PZ&B Staff Combination Memorandum: Landmarks Preservation Commission and Town Council

SUBJECT: ZON-24-0056 (COA-24-0021) 225 S COUNTY RD (COMBO)

MEETING: DECEMBER 18, 2024, LPC  
JANUARY 15, 2025, TC

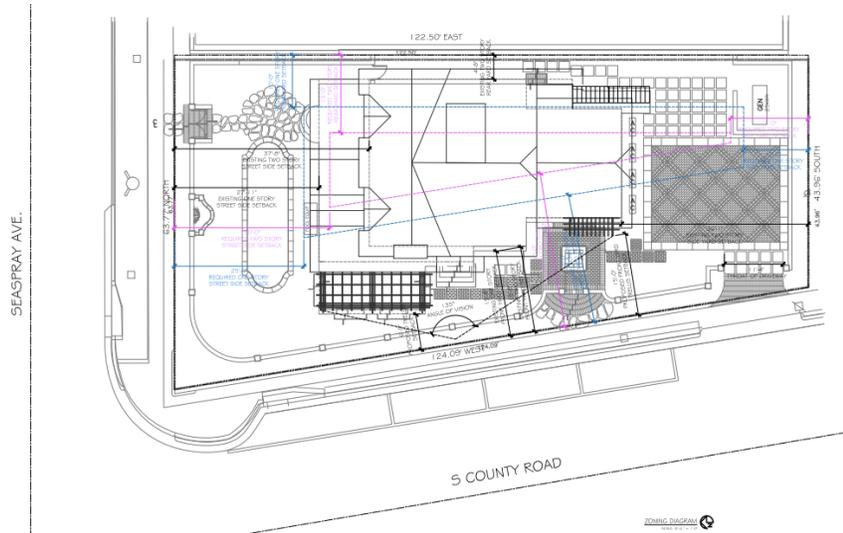
As depicted in the rendering above, the larger trellises will be located north of the main entrance and accessed by French doors that lead to a patio. The smaller trellis will be located south of the main entrance and will be located above a pair of French doors. This smaller trellis originally shielded garage doors. The new trellises will require two (2) variances which are discussed in the next section. In the original photograph, the rafter tails of the larger trellis covering the patio appear to depict a much more elaborate profile than the rafter tails proposed in this application. Staff recommends that the applicant consider a mindful reconstruction with those details.

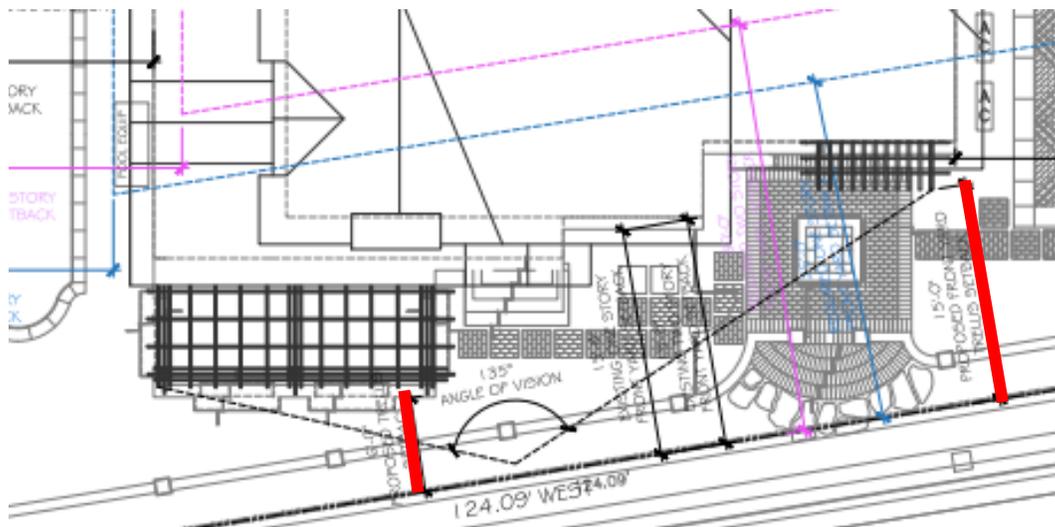
The existing residence has a nonconforming front yard setback along South County Road. South County Road is determined to be the “front” because of both the location of the front entry and the address. Due to the structure’s staggered design, certain portions of the west façade encroach more than others. Therefore, the installation of new trellises along the west façade of the structure will require variations since there will be further encroach on the front yard which triggers the need for a setback and angle of vision variation.

The larger trellis, located north of the main entrance, is proposed to have a setback of 6'-0" as measured from the property line along South County Road. Whereas the smaller trellis, south of the main entrance, will have a setback of 15'-0". The main residence has a setback of 14.3' at its furthest projection along the South County Road frontage. In the R-B zoning district, a front yard setback of 25 feet is required per Section 134-893(b)(5)(a).
